寄件者: WARREN WONG <[REDACTED]>
寄件日期: 2026年07月24日星期五 15:01
收件者: Adrian Tsz Hin TAM/PLAND
副本: Sheren Si Wai LEE/PLAND
主旨: FSIs proposal and reply of TD Comment of Application No. A/NE-TKL/844
附件: Departmental comments Response (TD) - TKL 844.pdf; FS Proposal at Fung Kat Heung (Full Set) - Submission- 23.July. 2026 - Rev. B.pdf

0	FS Proposal for Review	July, 2026
REV.	DESCRIPTION	DATE
PROJECT : Proposed Temporary Warehouse (Excluding Dangerous Goods Godown) with Ancillary Facilities for a Period of 3 years and Associated Filling of Land at Various Lots In D.D. 107, Fung Kat Heung, Kam Tin, Yuen Long, New Territories		
CLIENT :		
FS CONTRACTOR : FAITH WELL ENGINEERING LIMITED		
TITLE : GENERAL NOTES		
DRAWING NO. FKH2607/FS/01		REV. AF
DATE July, 2026	SCALE NA	
CHECKED BY CAD	DRAWN BY CAD	
FILE	DRAWING UNIT MM

Planning Application No. A/NE-TKL/844
Proposed Temporary Warehouse and Open Storage of Construction
Materials with Ancillary Facilities and Associated Filling of Land for a
Period of 3 Years

Response to the comments of Transport Department (TD) (as at 21 July, 2026)

Openable Window Layout of Structure (Side Elvvation) at G/F

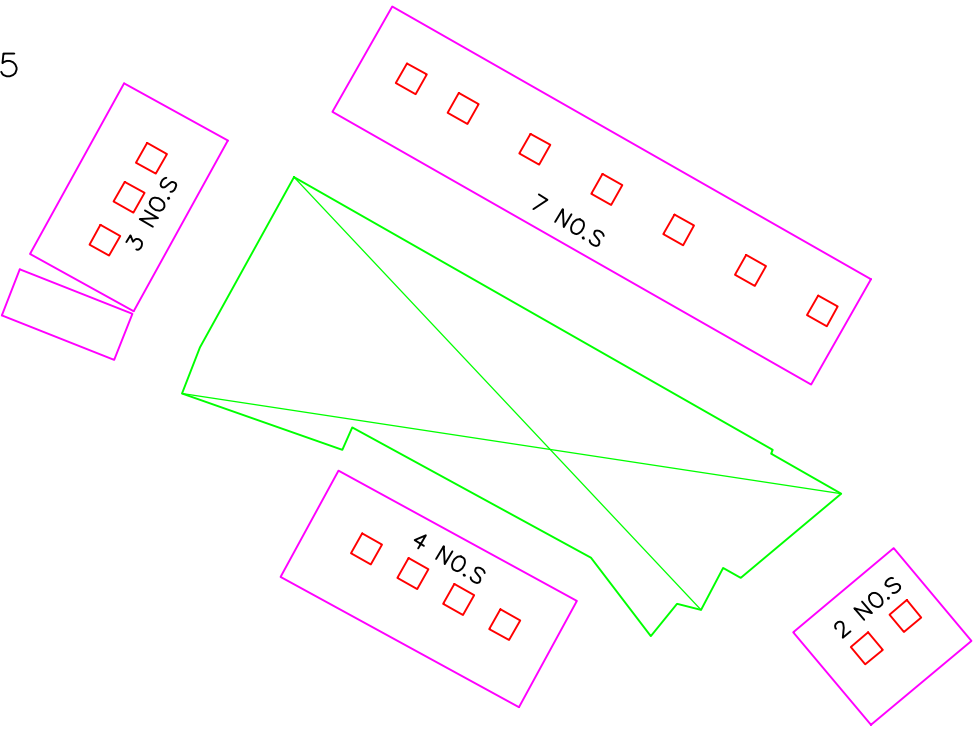
10. Static or Dynamic Smoke Extraction System is not provided. The openable Windows of Structure 1 with Aggregate Area Exceeding 6.25% of the Floor Area as Marked on Plans. (Details see openable window Layout Plan)

6.25% of The Floor Area is $520 \times 6.25\% = 32.5 \text{ sq.m}$

The aggregated area of Openable Window is :
 $1.0 \text{ sq.m} \times (3+7+2+4) \text{ No.s} = 36 \text{ Sq.m}$

$36 \text{ sq.m} > 32.5 \text{ sq.m}$
